Addendum #1	County	Adams
	Local Public Agency	Quincy
September 7, 2016	Project Number	MR 599B
	2016 Capital Roadway Improvements – Wards 4 and 7

2016 Capital Roadway Improvements – Wards 4 and 7

This addendum forms a part of the bidding and contract documents and modifies the original bidding documents dated September 1, 2016. Summary of changes:

FINAL SURVEY		BY	DATE
	SURVEYED		
	PLOTTED		
	TEMPLATE		
NOTE BOOK	AREAS		
	AREAS CHECKED		
NO.

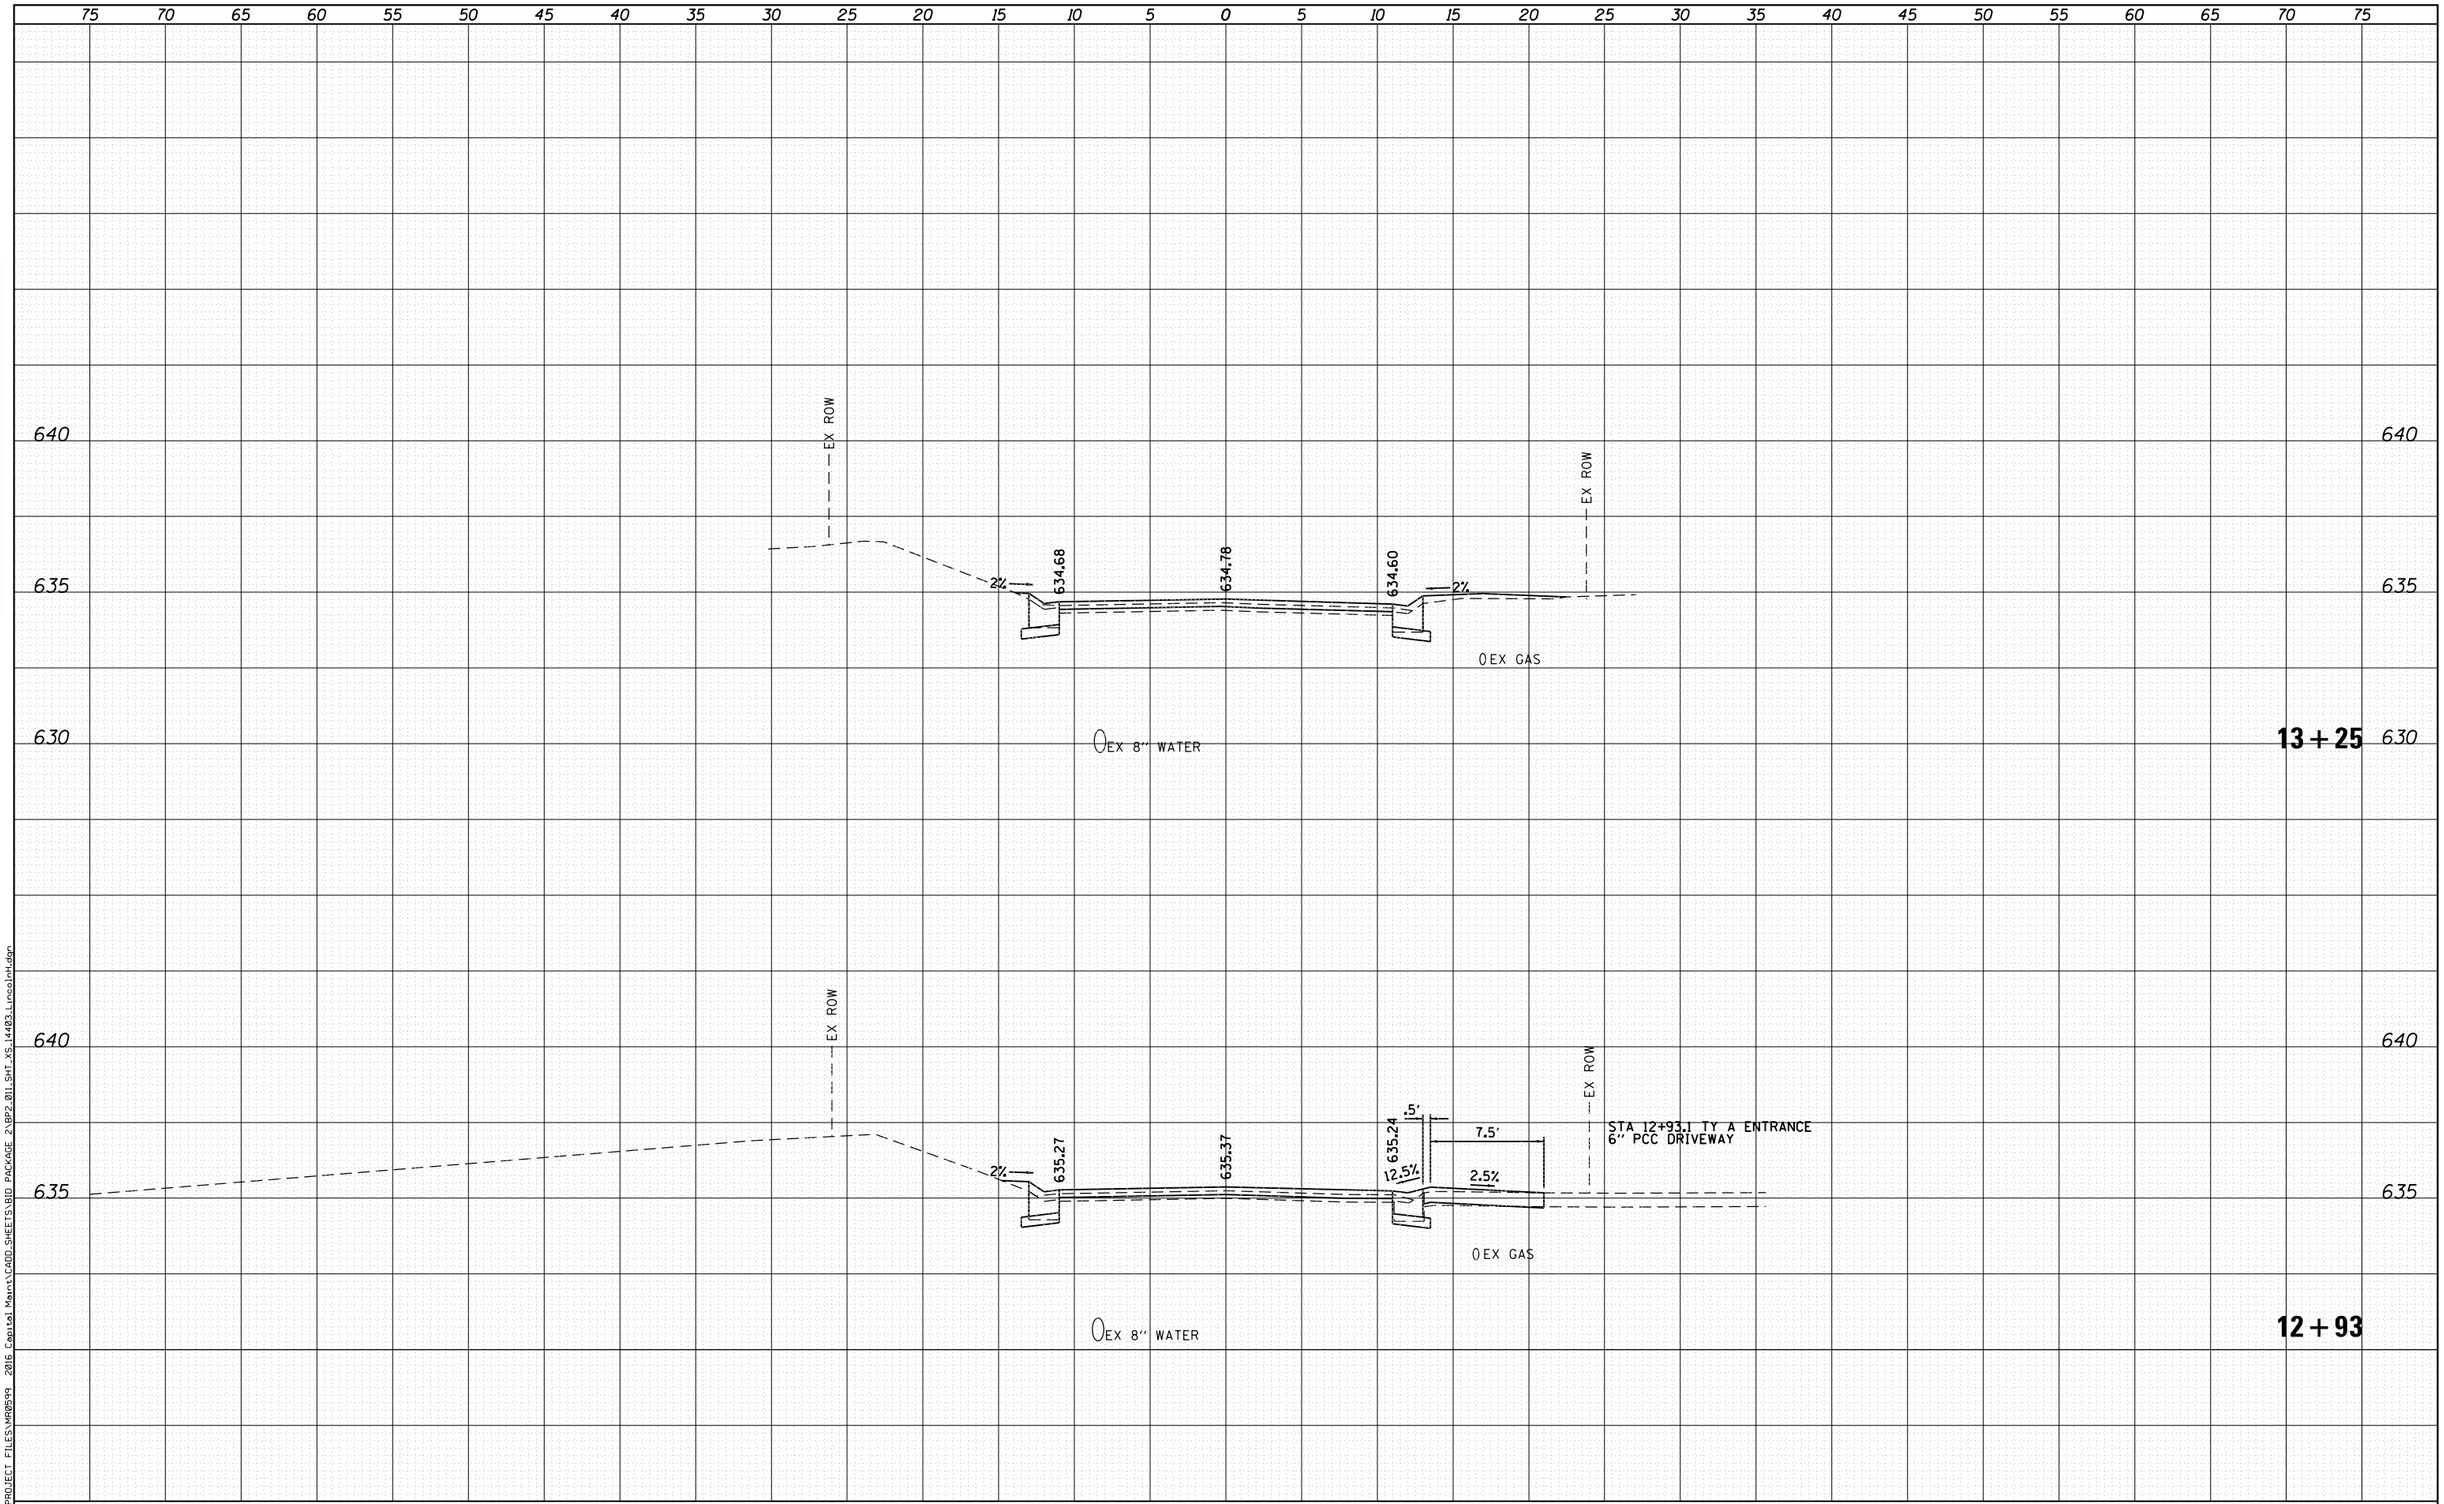
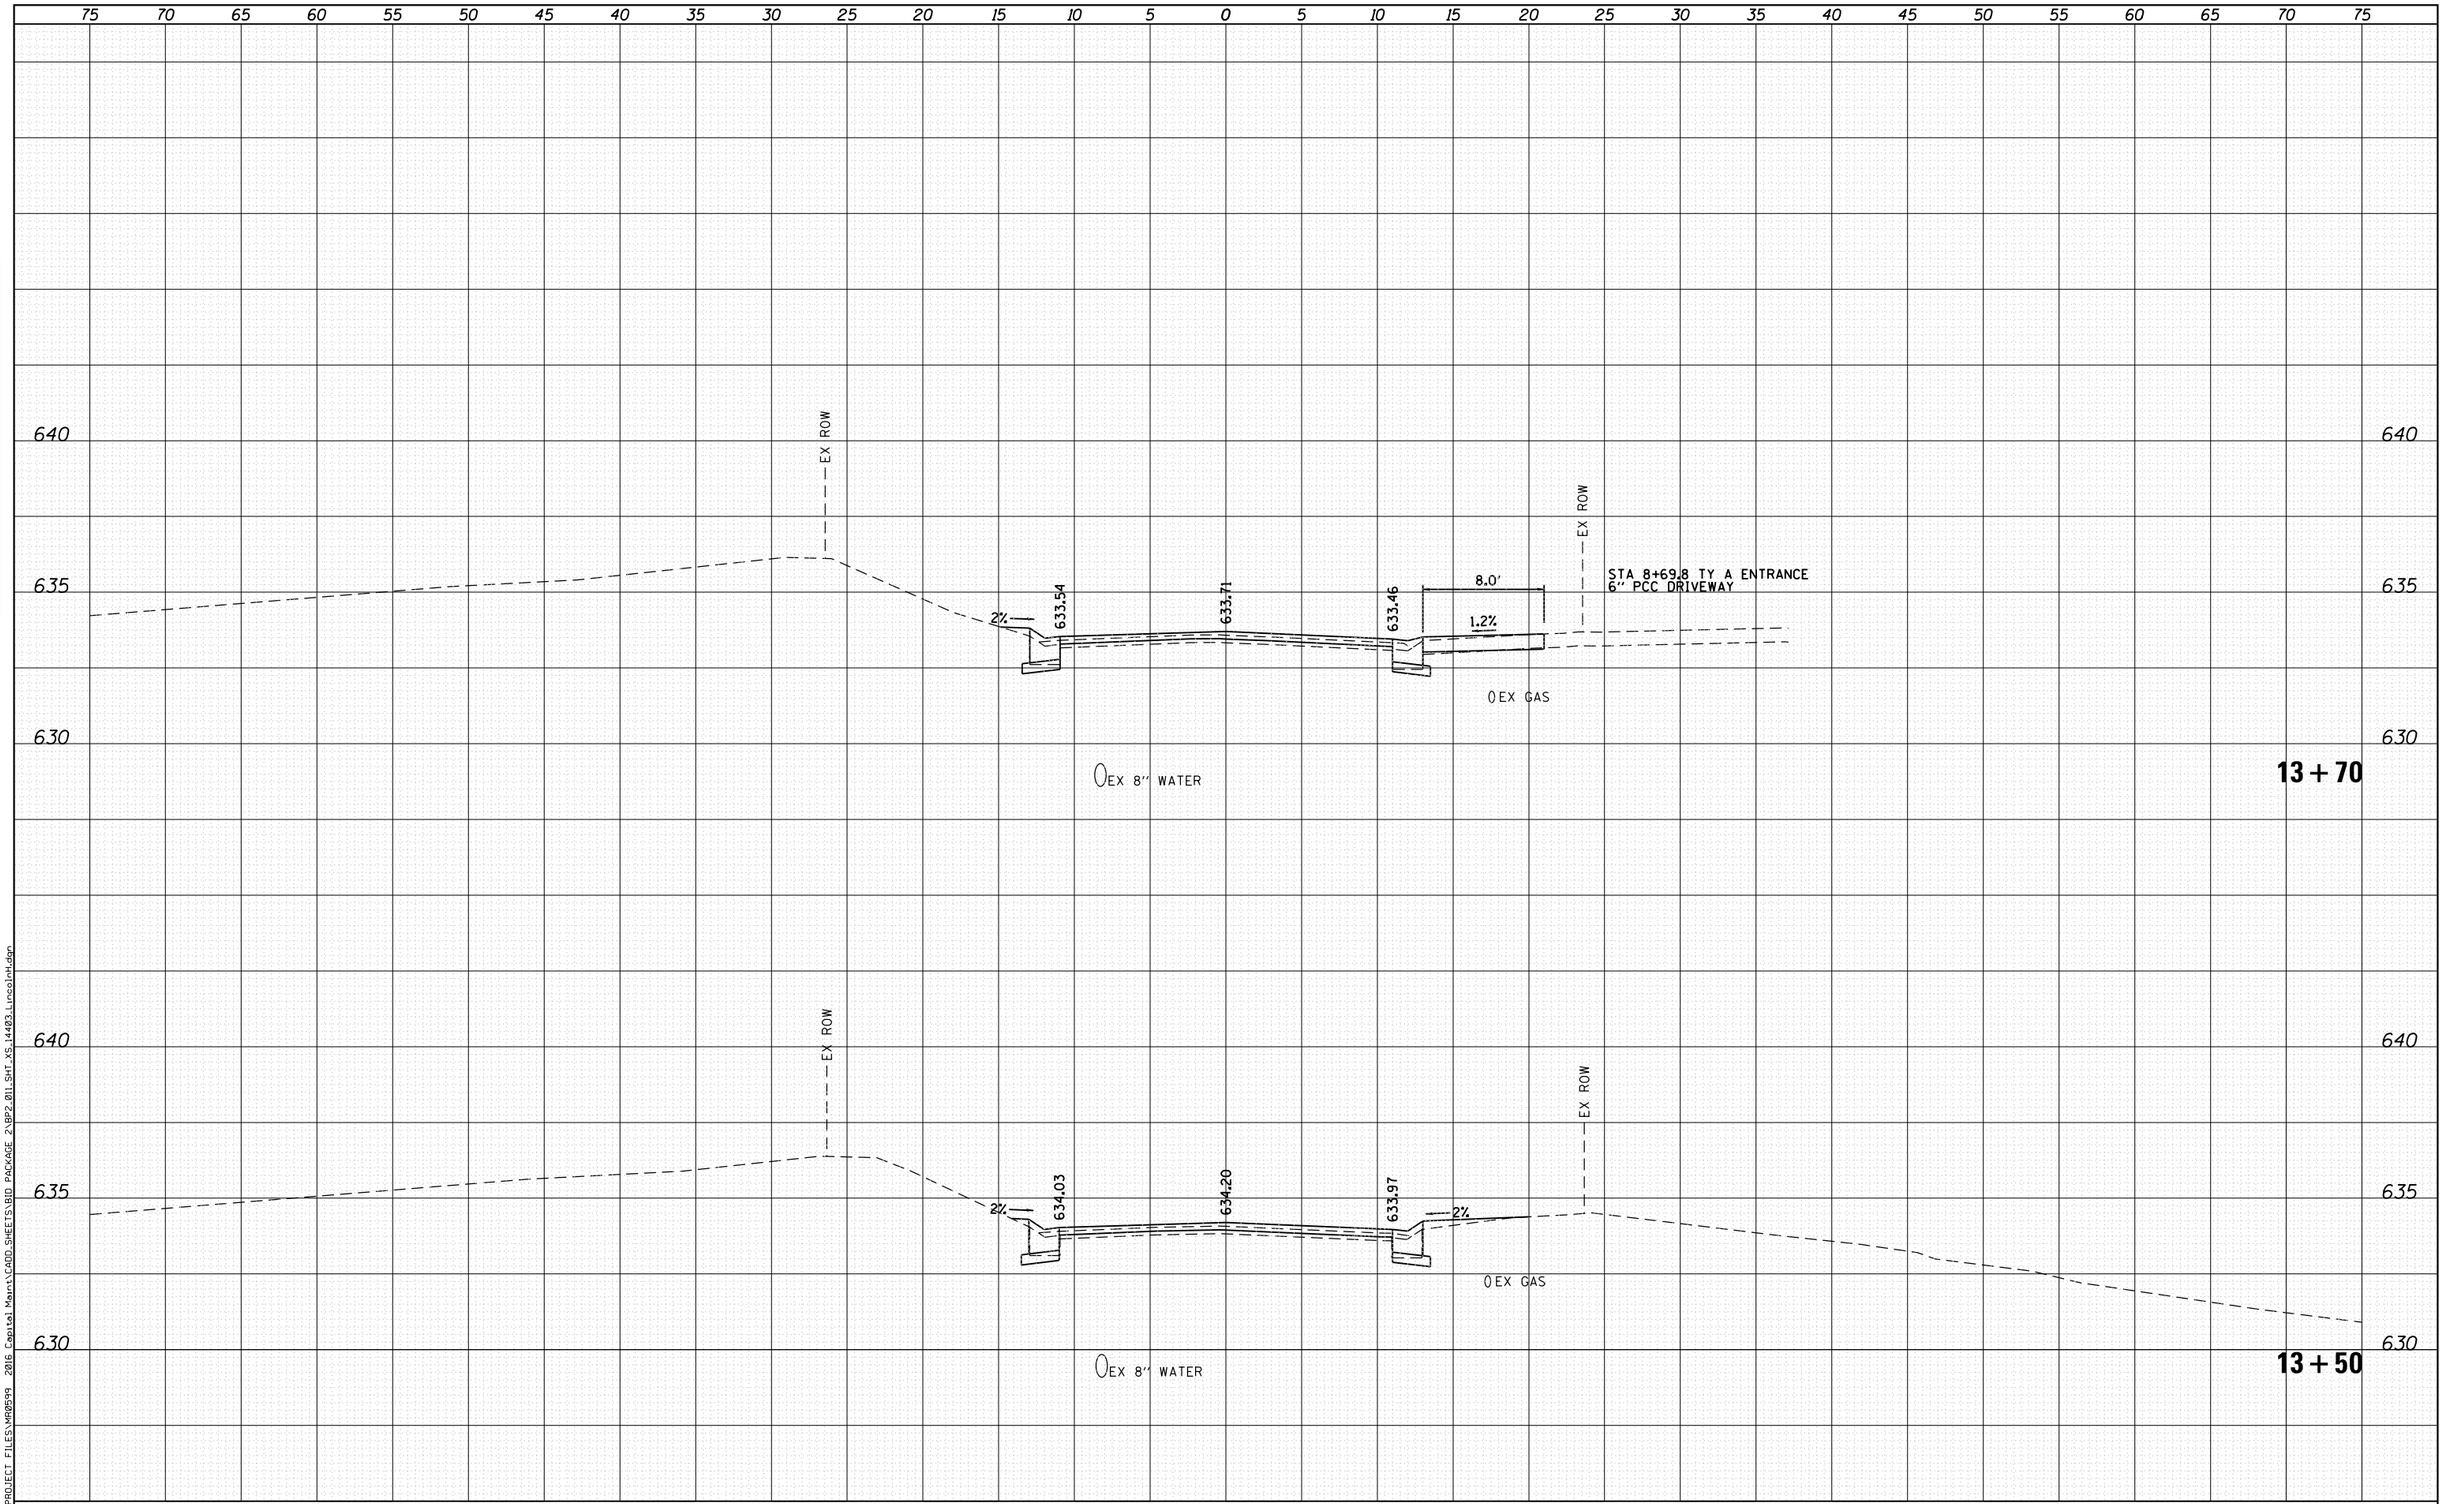
5. **SHEETS 17-23 of 44** - Added elevation labels for the edge of pavement.
